AIRWORTHINESS DIRECTIVE - GLIDERS

GFA/AD 101 DUSTER 1

Glider Type Affected: B.J.1B Duster

## FIN LEADING EDGE TIEDOWN DETAIL

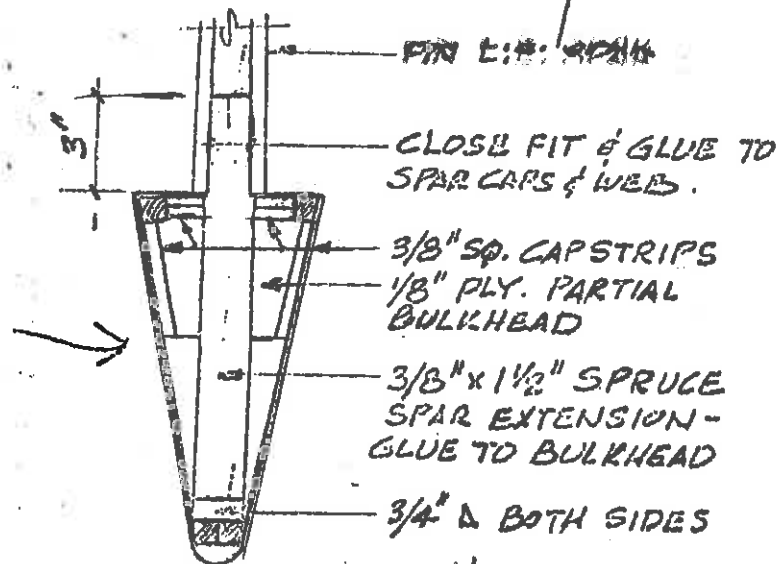
A number of cases of rudder flutter and separation of the fin from the fuselage of the subject glider type have occurred. This is attributed to structural inadequacy of the fin to fuselage attachment and insufficient mass balancing of the rudder.

1. The attachment of the fin is to be modified by the addition of a fin front spar extension from 1½" x 3/8" spruce with gusset blocks and partial bulkhead utilising an 1/8" thick plywood web and 3/8" Sq. cap strips. Additionally 3/8" Sq. spruce cap strip diagonals are to be incorporated into the root fin rib.
2. A smaller access hand hole is to be incorporated in the ply wood skin on rear left side of the fuselage with ¾" wide doubler.
3. ¾ x 1/8" ply doublers are to be fitted inside the fuselage skin at the cable exit points.
4. A new rudder is to be constructed with fabric covering and a counter balance built into the rudder tip. Fabric covering to be 1.7 oz. heat shrink Dacron ("Ceconite" or equivalent). Refer to attached drawing but preferably obtain revised drawing from supplier.

HOLLOW OUT FOAM-GLASS  
FAIRING & FILL W/ LEAD SHOT  
POTTED IN RESIN.  
BALANCE RUDDER AS  
CLOSE TO HINGE LINE  
AS POSSIBLE
